VERMONT YANKEE NUCLEAR POWER STATION

**OP 3533**

**POST ACCIDENT SAMPLING OF REACTOR COOLANT**

# REVISED PROCEDURE CONTROL FORM

**FIGURE 4**  
**TECHNICAL SUPPORT CENTER - COMMUNICATIONS ARRANGEMENT**

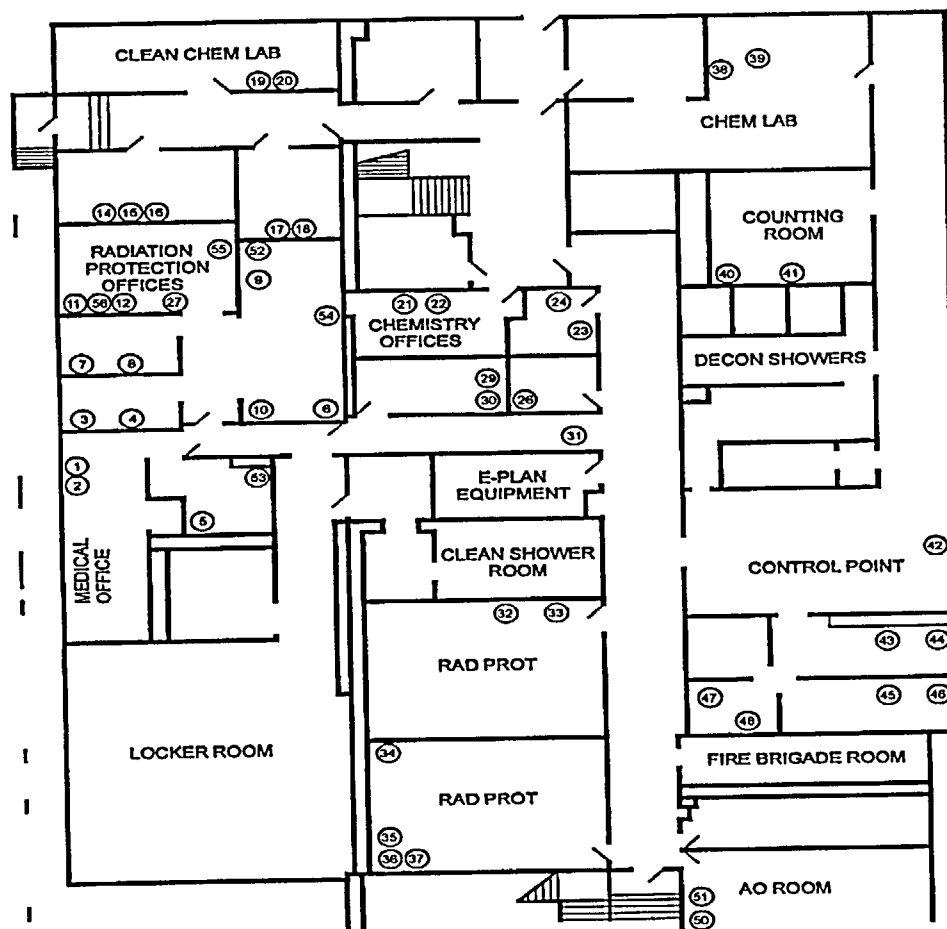
The changes to the Facility Layouts were to correct room names, delete phone designations that were no longer part of the E-Plan, add room numbers and correct the phone designations in the Conf. Rooms in the EOF/JNC. All of these changes were enhancements to the procedure and do not decrease the effectiveness of the Emergency Plan and continue to meet all requirements.

**FIGURE 6**  
**EMERGENCY OPERATIONS FACILITY/RECOVERY CENTER - COMMUNICATIONS ARRANGEMENT**

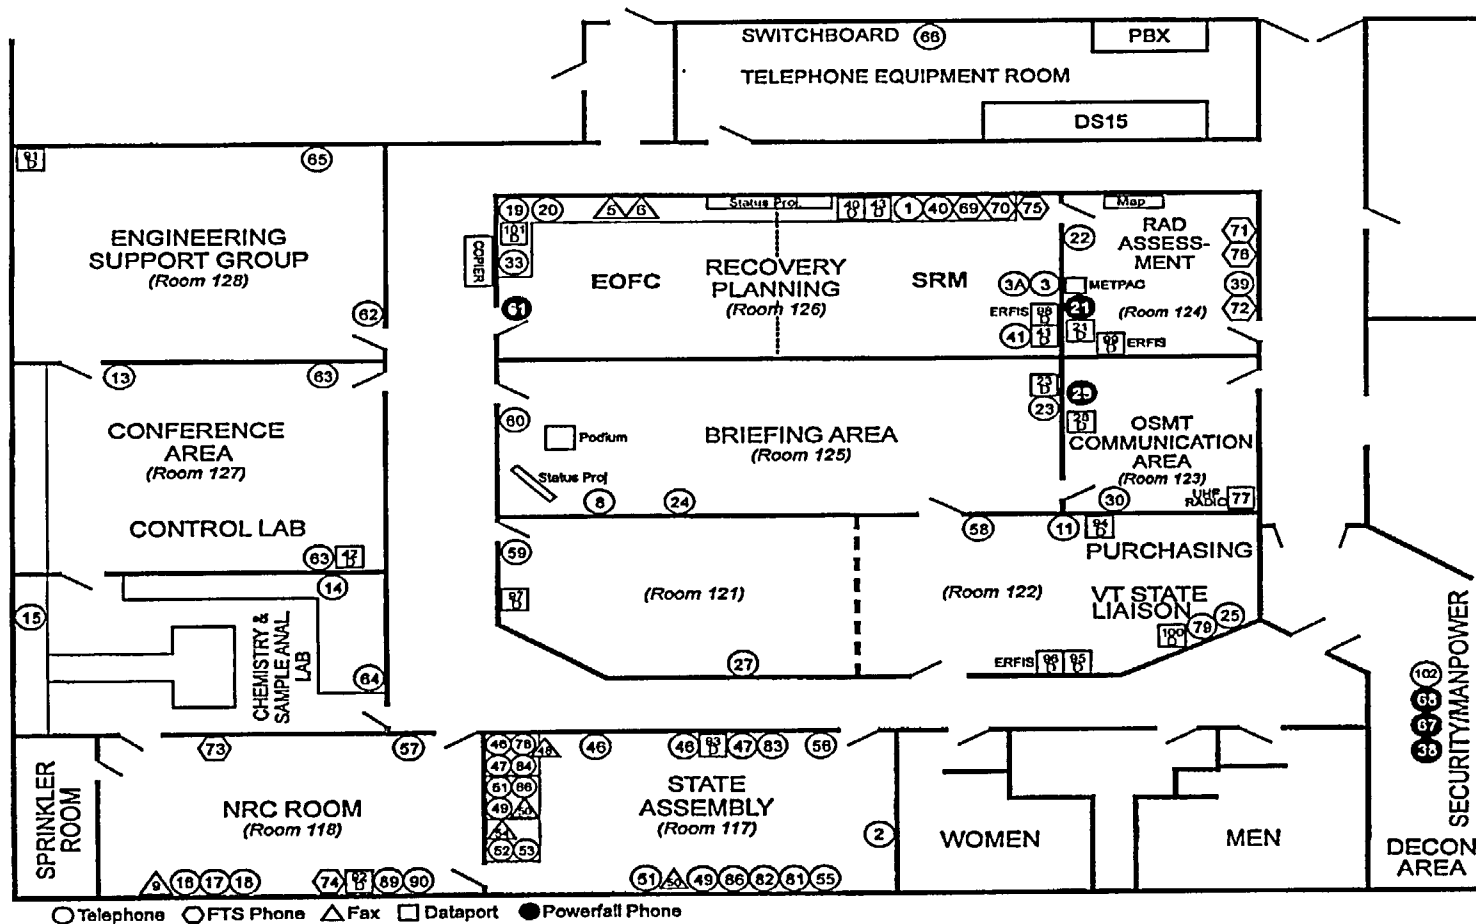
The EOF floor plan was changed to improve the facility. This change required phone extensions and some equipment as well as room designations to change. Manpower/Planning and Personnel & Equip Monitoring supplies were moved to the sprinkler room making it easier to obtain all of their equipment at once. The GHH monitoring team was eliminated and the equipment check needed to be removed from this procedure as well. The CVAX is no longer going to exist and IT changed the login procedure for the DECNET terminal which is reflected in the new instructions. Other minor changes identified during surveillances were made to improve procedure.
